REQUEST FOR INFORMATION (RFI)

PROJECT :	BKK2	R.F.I. NO. :	523213-01-RFI-AR-0011
TO :	CTA	ATTENTION :	CTA
SUBMITTED DATE:	20-Jan-26	NEED REPLY BY DATE :	27-Jan-26

SUBJECT : Request for Confirmation - Indicate Wall Structure and Wall Finishes Type for D22 6th Floor

Indicate wall structure, wall finishes for D22 6th FL

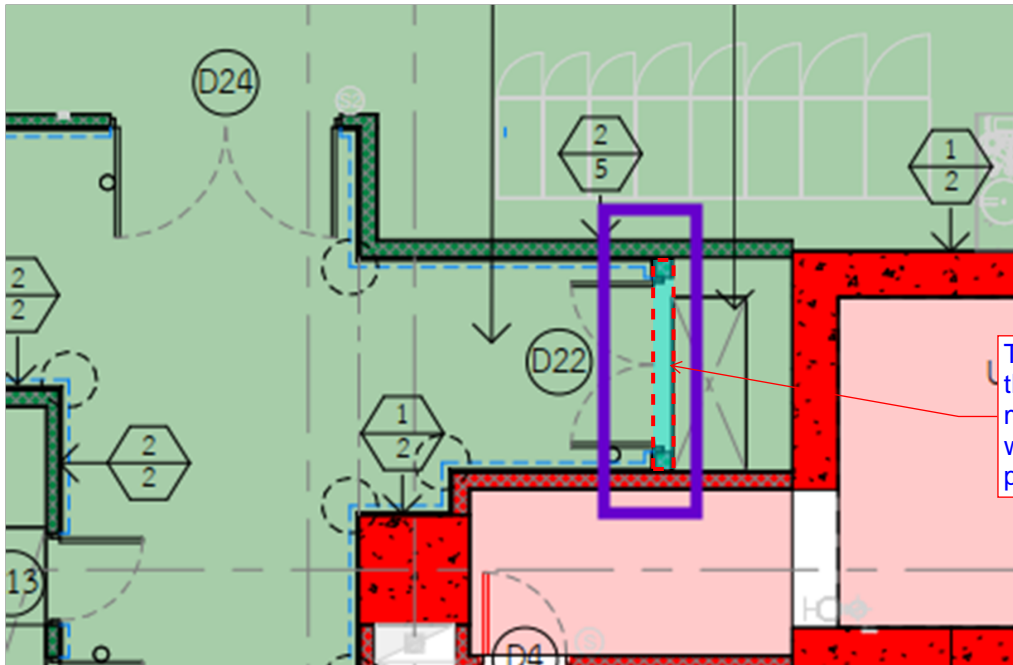
Indicate Wall Structure and Wall Finishes Type for D22 6th Floor.

Note : Aurecon to confirm the wall finishings for the highlighted areas

Note : SLA: Please refer to the notes in the attached markup.

The wall above and beside the door D22 shall be wall material 2 (block wall) and wall finish 2 (plaster and paint).
